Re: Technical Deficiency Letter (TDL)
Quaker Valley School District
NPDES Permit Application No. PAD020098
Leet Township, Leetsdale & Edgeworth Boroughs, Allegheny County

Technical Deficiencies

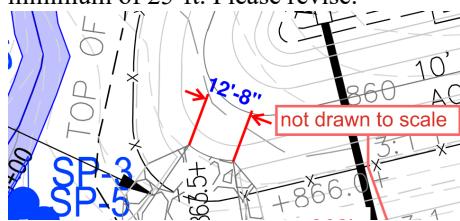
3. §102.4(b)(5)(ix), §102.8(f)(9): Please provide one overall plan sheet for each, the E&S and PCSM Plans, which depict the entire NPDES permit and Limits of Disturbance boundary.

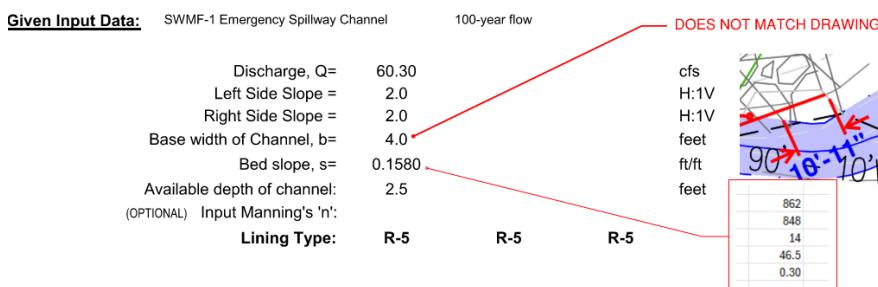
4. §102.4(b)(5)(ix), §102.8(f)(9): Please depict each proposed embankment emergency spillway to scale on both E&S and PCSM drawings. Currently the spillways appear to be drawn smaller than the design minimum of 25-ft. Please revise.

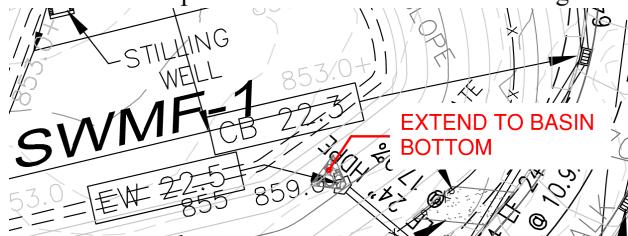
5. §102.4(b)(5)(ix), §102.8(f)(9): The Base width of Channel, b and Bed slope, s values used the Trapezoidal Channel Analysis design worksheets for the basin emergency spillway channels do not match what is depicted on the plan drawings for each basin. The spillway for SWMF-1 design values used for the width and slope are 4.0-ft and 15.8% for width and slope, respectively. However, the values estimated from the drawings provided are approximately 11-ft and 30%. Please revise each basin spillway channel designs to be more consistent with what will be constructed.

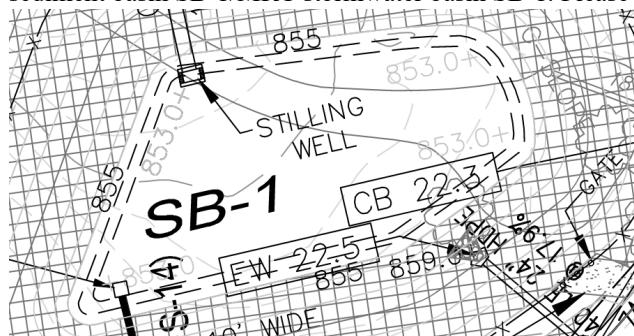
7. §102.4(b)(5)(ix), §102.8(f)(9): The Deed Book and Page Number of Tax parcel 704-C-223 show up on both the PCSM and E&S plan drawings as all Xs. Please revise.

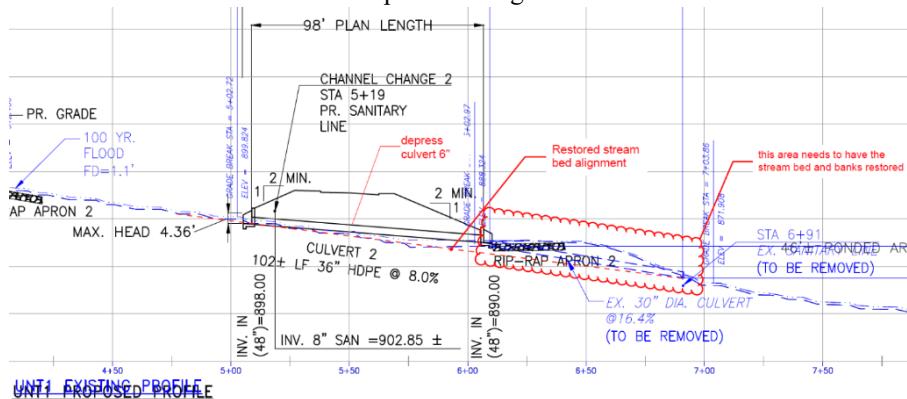
8. §102.4(b)(5)(ix), §102.8(f)(9): What do the two bold dashed lines represent at the interior base of the sediment basin SB-1/MRC stormwater basin SB-1. Please revise and/or explain.

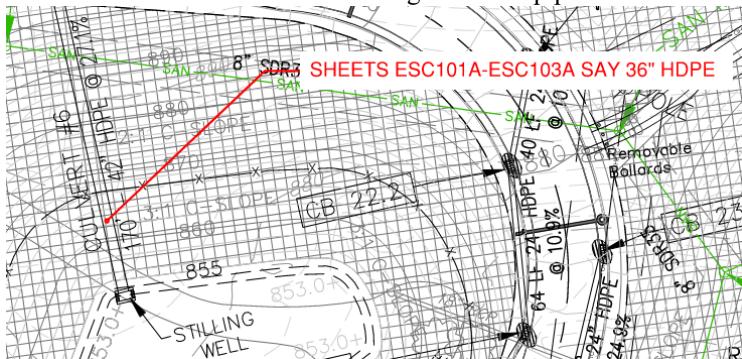
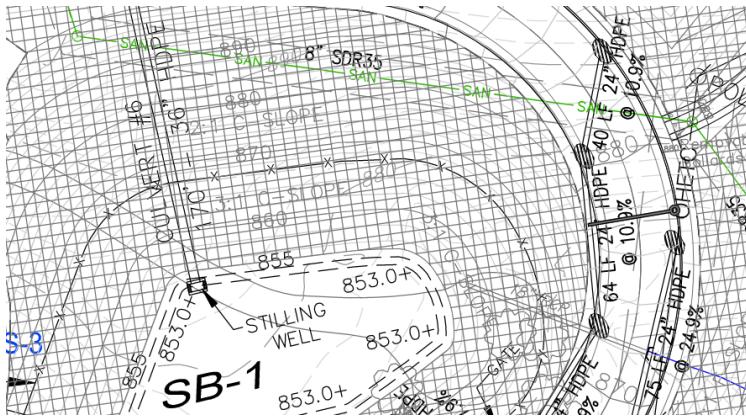
13. §102.4(b)(5)(ix), §102.8(f)(9): Sheet ESC104A depicts the Culvert #6 entering the basin SB1 as a 42" HDPE pipe. Sheets ESC101A-ESC103A depict this as 36" HDPE. The stilling well table on sheet PCSM300 indicates Culvert 6 as being a 36-inch pipe.

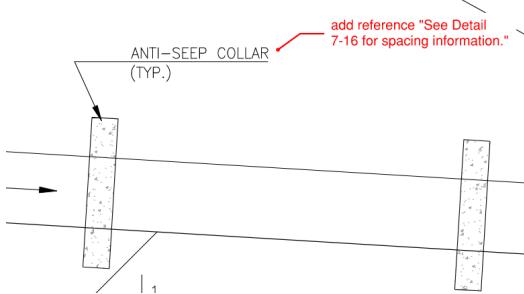
16. §102.4(b)(5)(ix), §102.8(f)(9): Please show and provide embankment impervious core information within the basin cross section detail on sheet ESC304.

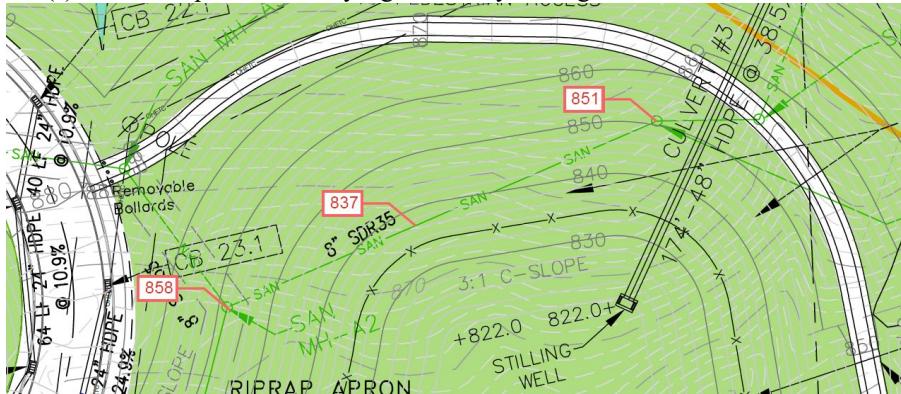
19. §102.4(b)(5)(ix), §102.8(f)(9): It is not clear how the proposed sanitary line cutting through basin SB-2/SWMF-2 cut slope will be constructed and accessed once constructed. There is a ~18-20-ft surface

elevation sag at the midpoint of the line between manholes MH-B1 and MH-A2. This will result in the need for excessively deep manholes to be constructed within the steep slopes. Consider placing the sanitary line(s) within the paved roadway/rights-of-way, easing construction and future access.

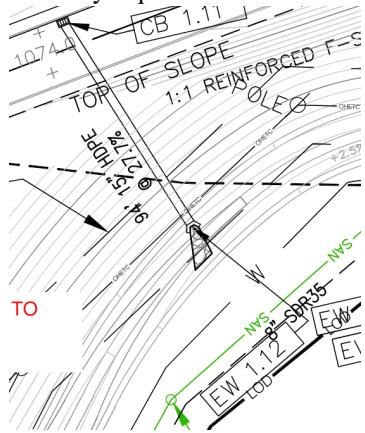
20. §102.4(b)(5)(ix), §102.8(f)(9): The proposed grading linework is at times difficult to differentiate from the existing grading. The sheets appear to depict the proposed grading contour linework as a lighter color than the existing grading contour linework. In addition, the proposed green vegetation hatching color obscures and makes it much harder to see other drawing information. Please consider lightening the hatch color, increase the opacity, or eliminate it all together. This vegetation information only needs to be depicted once and can be easily displayed on a landscaping/planting plan (not provided) depicting proposed plantings throughout the site. Please revise.
21. §102.4(b)(5)(ix), §102.8(f)(9): Please update the drainage divide line to represent the later E&S phase and PCSM phase drainage patterns. As depicted, it no longer represents the drainage patterns of these phases.

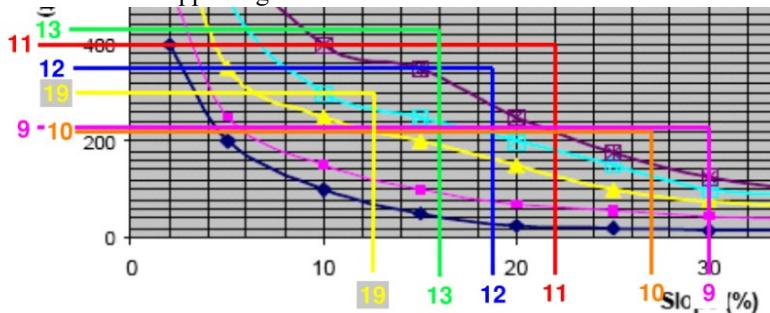
30. §102.4(b)(5)(ix): End wall EW1.12 shown on sheets ESC104C and PCSM100C is depicted with a downstream outfall riprap apron, however the table located on sheet PCSM300 indicates that no riprap apron is proposed for this outfall. Please review each proposed end wall and corresponding outlet and make sure they depict information consistently. Please clarify.

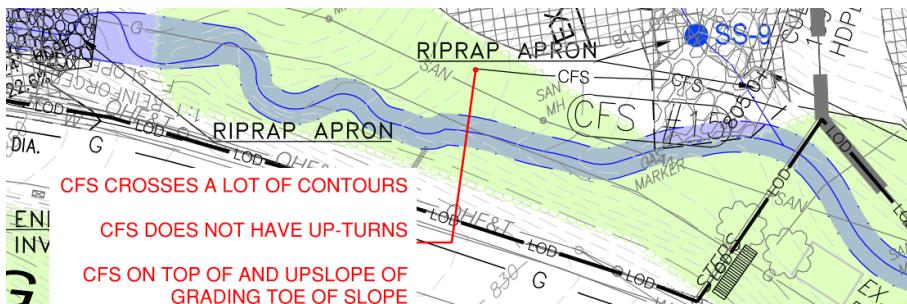
33. §102.4(b)(5)(viii): A spot check of compost filter sock slope percents and slope lengths indicated on Standard E&S Worksheet #1, for socks 9 through 13 and 19, appear to be incorrect. Each design appears to exceed the slopes/lengths for 32-inch for socks 9-13 and 24-inch sock 19. Consider the use of a sediment trap or other BMP with appropriate capacity for use within the watershed of socks 9-13. Review all CFS sizing and ensure that the maximum slope lengths are used for sizing in all areas. Update the drawings and provide revised supporting calculations.

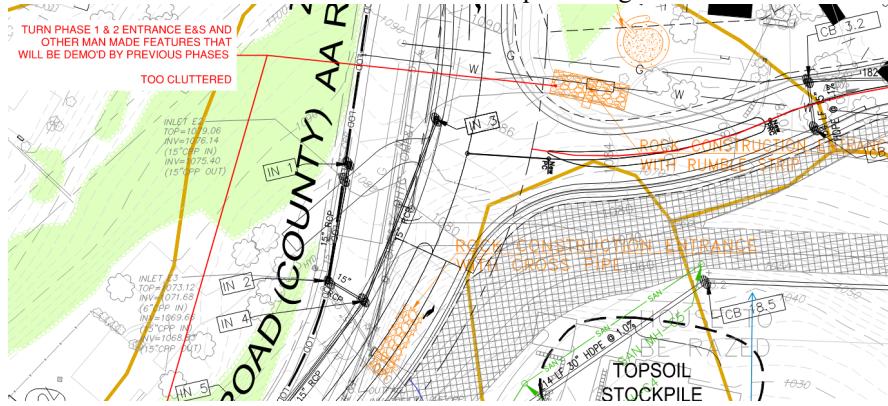
44. §102.4(b)(5)(viii), §102.4(b)(5)(ix): The proposed permanent access from the Camp Meeting Road has an approximate 11% slope and has large upslope drainage areas. Per the 2012 E&S Manual, “Due to the nature of broad-based dips, they should not be constructed on roads with grades exceeding 10%. Where access roads exceed 10% gradients, in-sloping or other deflection devices should be used to control runoff.” A roadway graded with an in-slope, at least temporarily would allow runoff to be captured by a channel and directed to sediment trap or other BMP. Additionally, check-dams could be used along this channel to aide in control of the runoff. If an in-slope option is used, include slope arrows to indicate the in-sloping direction. As currently depicted, channels would need to be provided on both sides of the access roadway. Please revise the plans to include adequate access roadway BMPs along the entire length of the access roadway. Provide information within the construction sequence, making it clear to the contractor how this access roadway is to be constructed, both temporarily, and during the final construction phase.

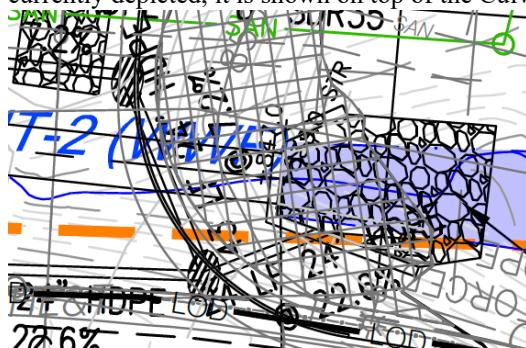
45. §102.4(b)(5)(ix): To aide in de-cluttering the drawings, please remove outdated previous phase BMPs, when depicting the final E&S phase. For example, Rock Construction Entrance # 4 will no longer be accessible once the new drive access off of Camp Meeting Road. Please revise:

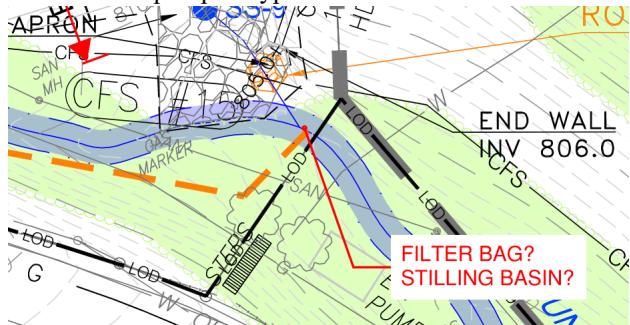
46. §102.4(b)(5)(ix): The erosion control blanket (ECB) hatching scale/color should be toned down. As currently depicted, it obscures much of the important basin construction related information. In addition, as currently depicted, it is shown on top of the Culvert #5 riprap apron. Please revise.

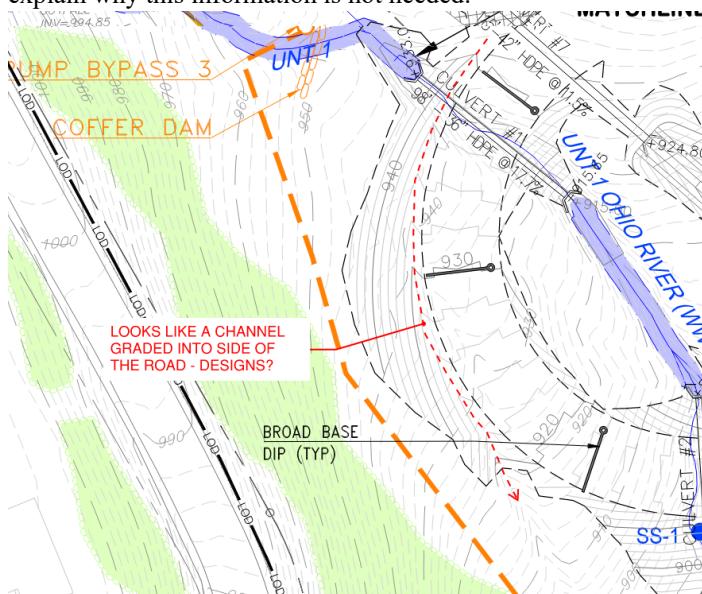
47. §102.4(b)(5)(ix): Provide a properly designed and sized stilling basin or other equivalent anti-scour BMP at the Culvert 5 pumped bypass outlet.

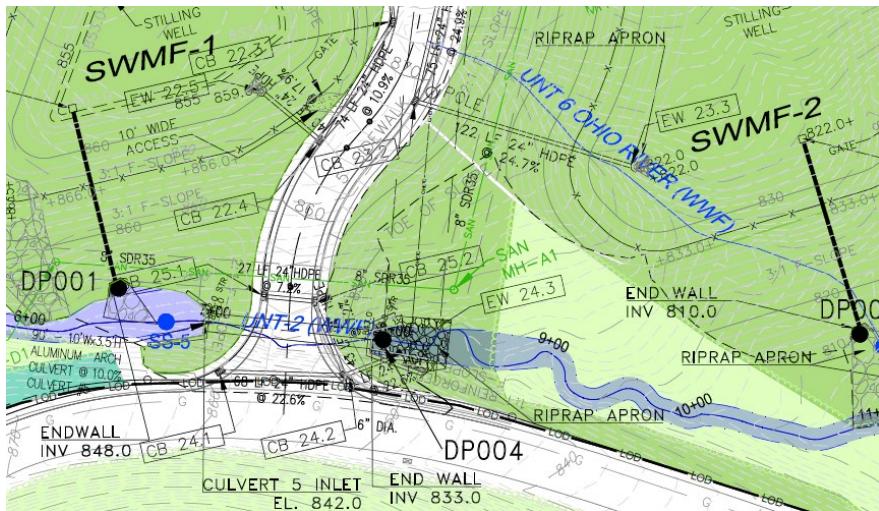
49. §102.4(b)(5)(ix): The PCSM plan drawings are very cluttered and messy. They still depict many items proposed for removal during the demolition phase of the project. For example, the existing guide rail crossing the proposed driveway entrance off Camp Meeting Road, as well as the UNT 6 which is to be eliminated through the construction of the basin SWMF-2 are still depicted on both the PCSM and E&S drawings. Please remove all features to be removed during the demolition and erosion and sedimentation control phases, as these items clutter the provided mapping, making it difficult to read. These include streams, utilities, structures, and other man-made items. Please revise.

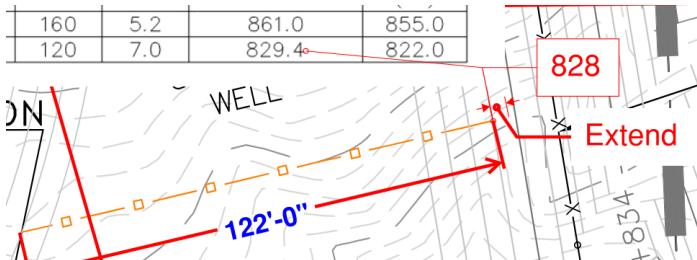
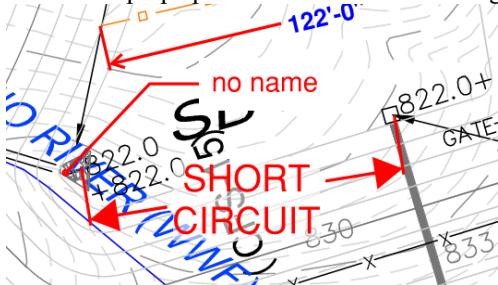
50. §102.4(b)(5)(ix): The sediment basin baffle line types should be identified on the plan view drawing legends. Additionally, the way they are depicted on the plan drawings, it is difficult to understand the orientation with which they are to be installed. The baffle for SB-2 appears to be randomly placed within the center of the basin. One end of the baffle should be placed such that the top of the baffle terminates at the basin embankment. As currently depicted, the baffle extends to the 828 contour on the right side, leaving a gap and allowing flows greater than 828 in elevation to escape and pass along both sides of the baffle. This baffle should be depicted farther to the right and extend to the approximate 829.4 elevation. See screenshot below:

Additionally, sediment basin SB-2 still is being short circuited by the flows entering into the basin via unnamed riprap apron 24-inch HDPE discharge from the proposed access road. Please revise.

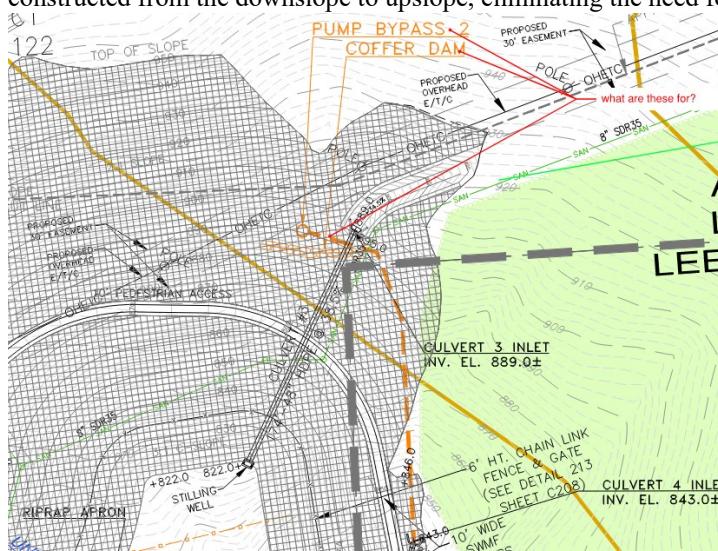
51. §102.4(b)(5)(viii), §102.4(b)(5)(ix): The permanent riser crest elevation for sediment basin SB-1 listed in the Standard Construction Detail # 7-2 (861.0-ft) in Module 1 and on sheet ESC304 differs from the elevation identified on the plan drawings (860.2-ft). Please revise.
52. §102.4(b)(5)(viii), §102.4(b)(5)(ix): Please provide proper construction details for the proposed compost filter sock sediment trap.

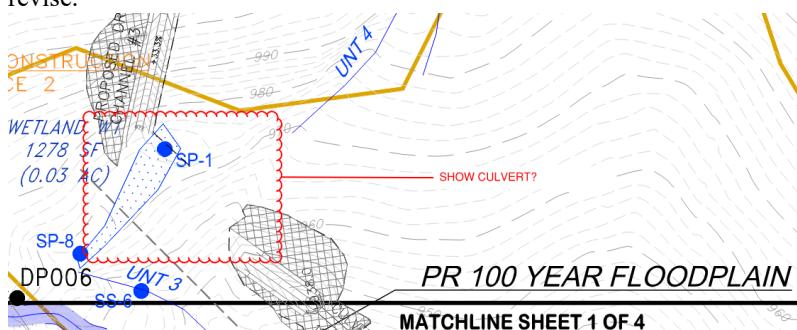
55. §102.4(b)(5)(viii), §102.4(b)(5)(ix): Please explain the need for the coffer dam and Pump Bypass #2 to Culvert #4. As depicted, it appears the construction of collection channel #1 is being proposed prior to the construction of the sediment basin SB-2. Collection channels should not be constructed until after the completion of the sediment basin. Inlet/outlet structures entering and leaving the basin should then be constructed from the downslope to upslope, eliminating the need for upslope bypassing.

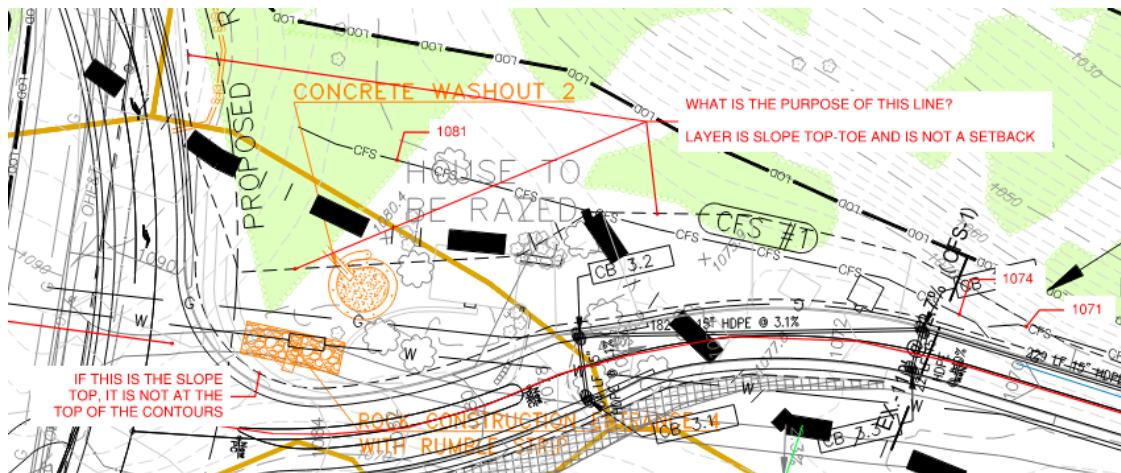
56. §102.4(b)(5)(ix): Please show the Culvert # 7 along with the Channel #3 grading on sheet ESC103B. Please revise.

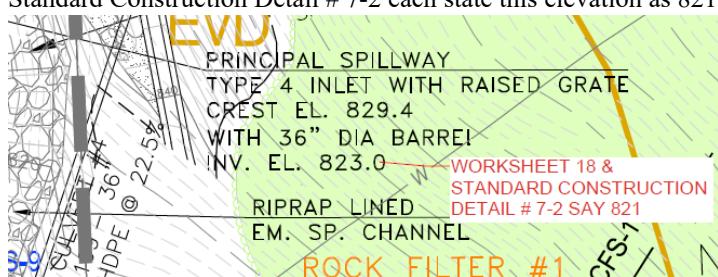
62. §102.4(b)(5)(ix): The plan drawings call the principal spillway barrel invert as 823.0-ft. Worksheet 18 and Standard Construction Detail # 7-2 each state this elevation as 821-ft

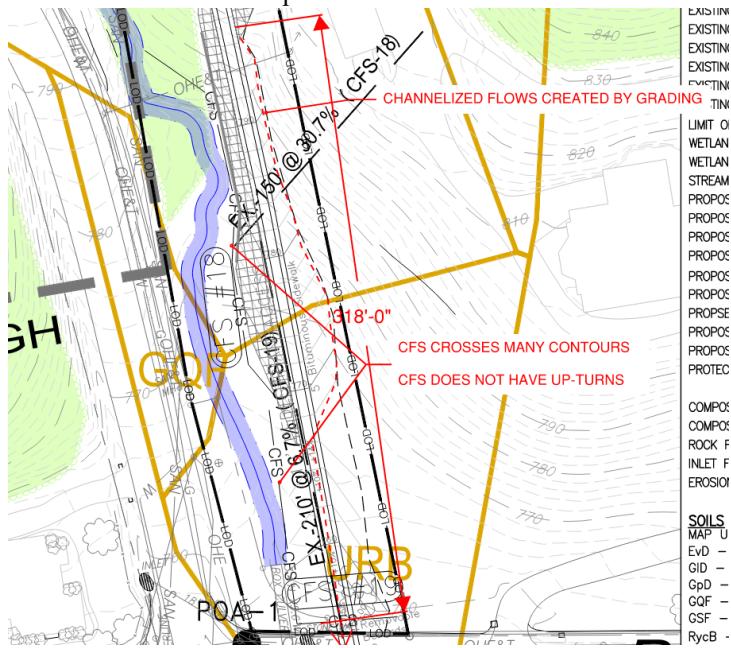
63. §102.4(b)(5)(viii), §102.4(b)(5)(ix): The proposed bituminous Sidewalk pathway north of and connecting to Camp Meeting Road is sloped at an average 12.5% for approximately 320-feet and is graded such that it will capture upslope runoff, channelize and discharge uncontrolled directly to Camp Meeting Road. Will

this pathway grading need to meet ADA compliance? If yes, this may affect how runoff from this pathway can be directed. Please explain and/or revise.

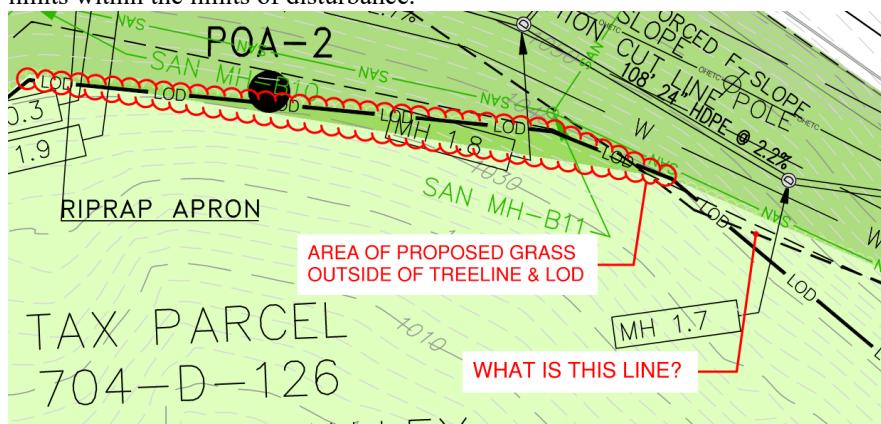
through grading and be sure to include this information in the E&S and PCSM Plans. It is suggested that all B soils be shown degraded to C or D as appropriate in post-construction conditions. Please revise.

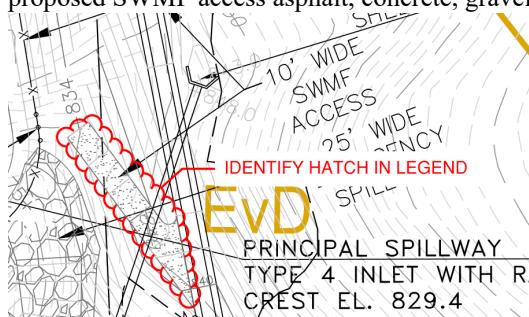
71. §102.8(f)(9): The LOD linework on sheet PCSM100C is being crossed by the proposed grass surface cover and an unidentified bold black dashed line that appears to arbitrarily terminate within the sheet and extends east onto sheet PCSM100D. Please revise to keep the proposed surface vegetation change and grading limits within the limits of disturbance.

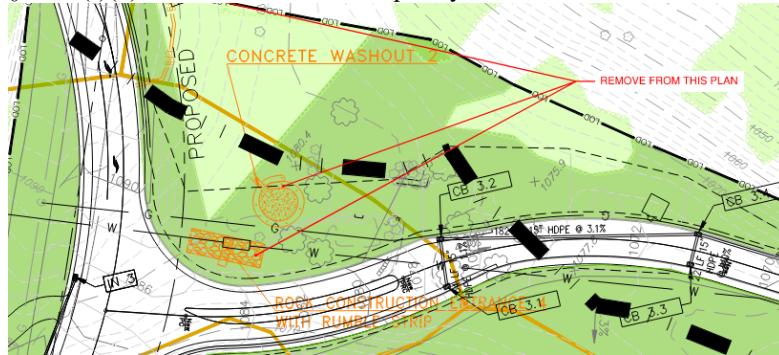
74. §102.8(f)(8), §102.8(f)(9): Consider the use of check-dams along the permanent channels to aid in control of the runoff and obtaining water quality volume.

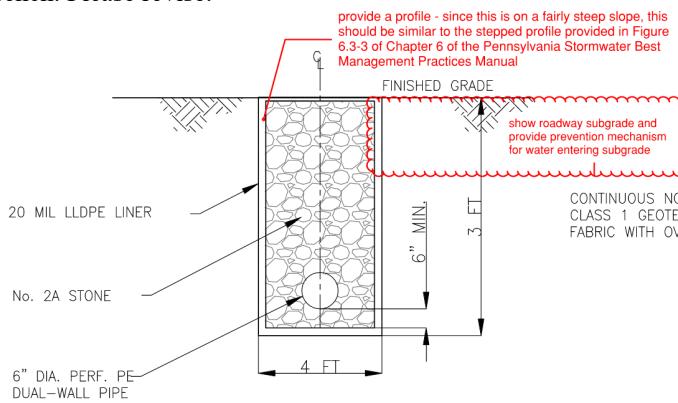
77. §102.8(f)(9): Please identify Camp Meeting Road on each plan sheet it appears on. (PCSM100B)

ROCK TRENCH DETAIL

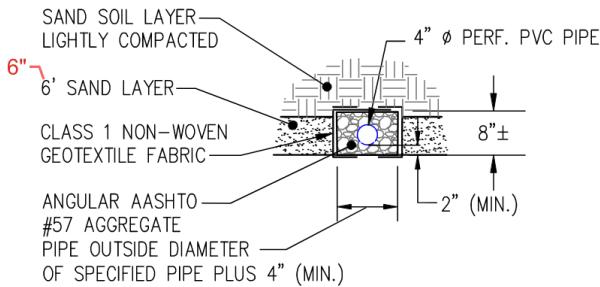
78. §102.8(f)(9): Please revise the rock trench detail to show the roadway cross section, including the subbase and provide prevention mechanism for water entering the subbase. Additionally, provide a profile. Since this rock trench is on a 10% slope, the profile provided should be similar to the Figure 6.3-3 stepped profile provided in Chapter 6 of the Pennsylvania Stormwater Best Management Practices Manual. Proper measures should be taken to prevent water infiltrating into the subbase of impervious pavement. Consider placing the rock trench on the fill-slope side of the roadway, below the subbase layer, with a cut-slope side swale with catch basins and cross culverts discharging into the infiltration trench. Catch basin sumps and water quality filters can then be placed in the catch basins to be used as pre-treatment for the infiltration trench. Please revise.

TYPICAL BASE DRAIN

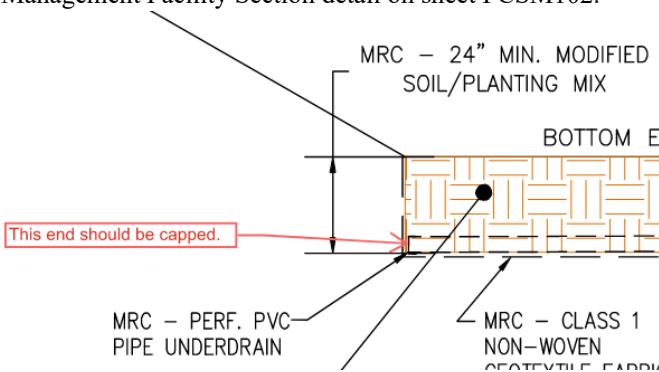
79. §102.8(f)(9): The Typical Basin Drain detail on sheet PCSM102 references 6-ft thick sand layer. It is likely this is meant to read as 6-in thick. Please revise.
